Finding of No Significant Impact

Yellowstone River – NE of Livingston

BR 11-1(44)56 Control Number 4790

**FEDERAL HIGHWAY ADMINISTRATION
FINDING OF NO SIGNIFICANT IMPACT**

Figure 2.5 Alternative 1: Bridge Superstructure and Piers with Hammerhead Pier Cap

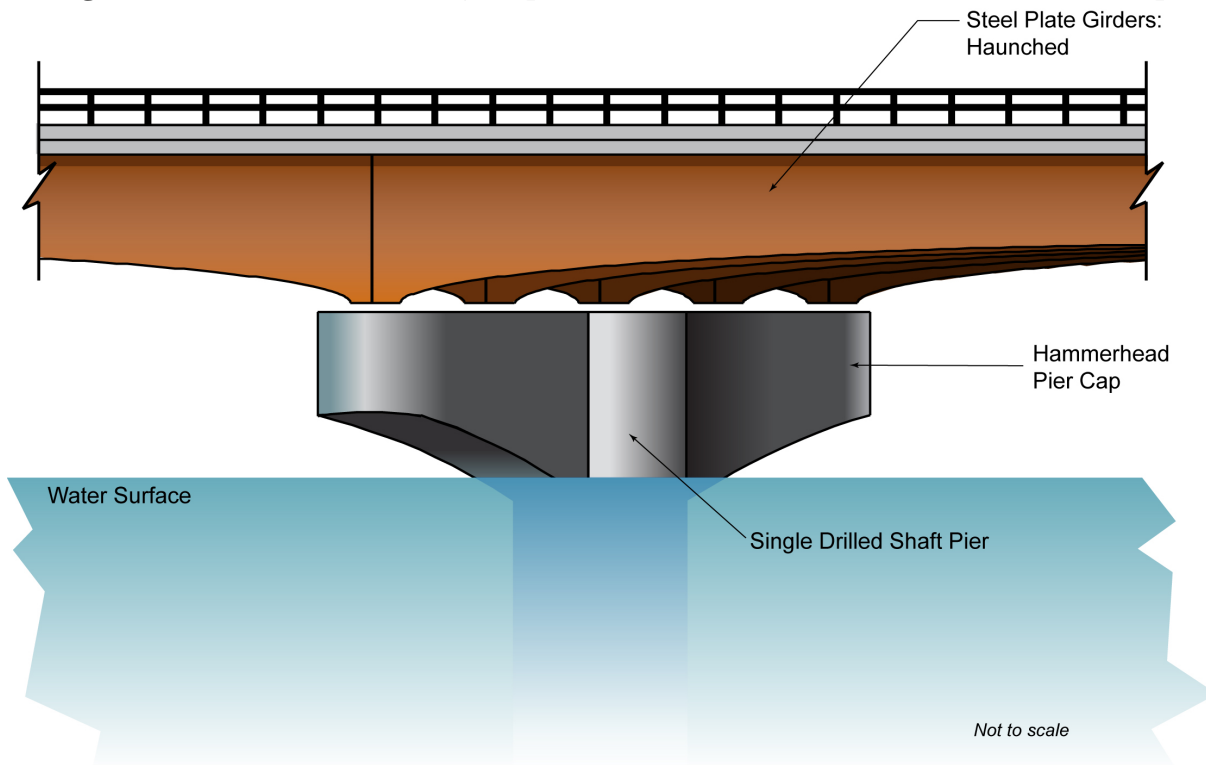
Girders – MDT considered using a haunched girder with a drop cap, as shown in Figure 2.5 of the EA, to enhance the aesthetics of the bridge by providing continuity and a smooth flow of horizontal lines. As the preliminary design progressed, it was determined that the drop cap would not clear the 100-year flood elevation. It would be necessary to raise the vertical grade of the bridge deck and roadway approaches even more than already proposed to use a haunched girder design with a drop cap design that would clear the 100-year flood elevation. This would increase impacts to the adjacent natural habitat and private property and would increase the cost of the bridge substantially. The other option, shown in Figure 2.6 of the EA, uses an integral cap above the 100-year flow without raising the grade of the entire bridge deck and roadway approaches. Unfortunately, this design would create a discontinuity in the horizontal girder line, which would be less desirable from an aesthetic perspective. Therefore, MDT has explored other options including using a drop cap with parallel flanged girders. This would provide continuity and a smooth flow in the horizontal girder line while clearing the 100-year flood elevation. These bridge elements will be refined and determined during final design, but it is unlikely that haunched girders would be part of the ultimate design of the bridge.

Figure 2.9 Alternative 1: US 89 and Bennett Street Intersection

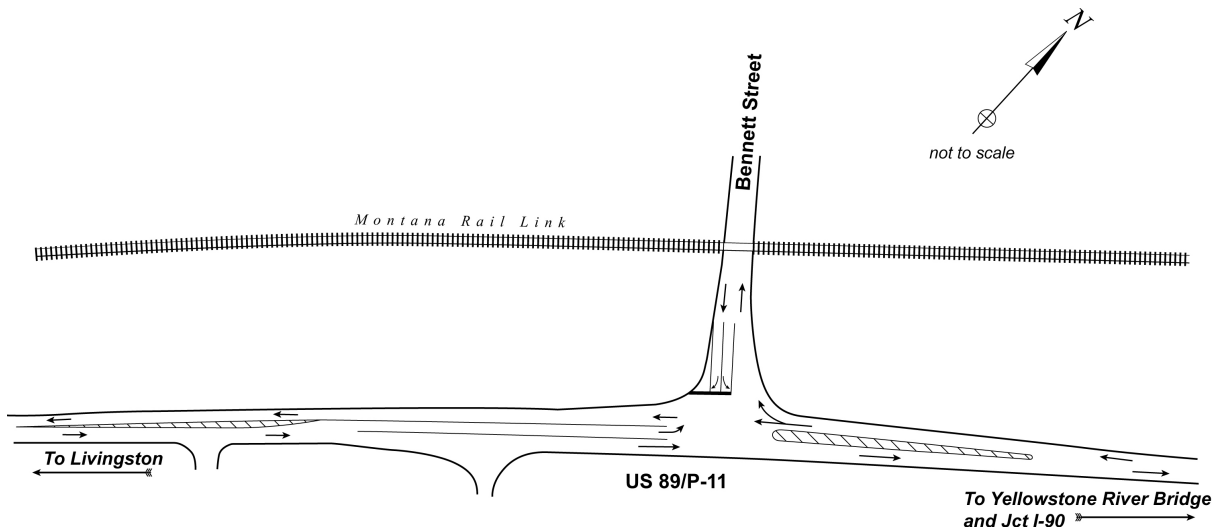
The proposed reconstruction of the Bennett Street intersection was a concern of local government representatives as well as the public. The primary concern is about the ability of the proposed intersection to accommodate stopped traffic during train delays at this location. A grade-separated railroad crossing at Bennett Street was suggested by local representatives and residents as one potential option to address this existing problem at the intersection. Implementing a grade-separated railroad crossing at Bennett Street as part of this project is not an option because this is a bridge replacement project funded through the Bridge Replacement and Rehabilitation Program. As discussed on page 2-7 of the EA, the intersection of Bennett Street and US 89 is proposed for reconstruction as part of this bridge replacement project because the project limits extend out along US 89 past the intersection and require some degree of intersection reconfiguration due to the proposed change in vertical grade and horizontal alignment of US 89.

The previously proposed reconfiguration of the Bennett Street intersection would accommodate approximately 22 vehicles. MDT has modified the proposed intersection design to accommodate approximately 25 vehicles. There would be space for four vehicles on Bennett Street between the train tracks and US 89. The full-width storage length of the left-turn bay would accommodate approximately 21 vehicles. This would provide one additional car length of storage than is currently available under existing conditions.
